5600204 COATING NEW STRUCTURAL STEEL
COMMENTS FROM INTERNAL/INDUSTRY REVIEW

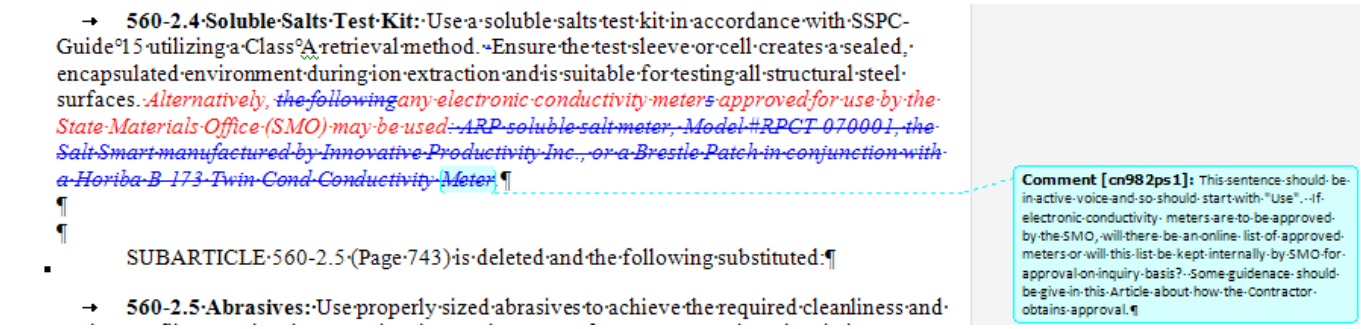
Comment: (10-12-12/10-15-12)
560-2.4 – What is the basis for this approval by SMO? Those requirements should be stated in the spec.
The changes to 560-2.4 and 560-6.3 are not supported by SCO.
1. 560-2.4:
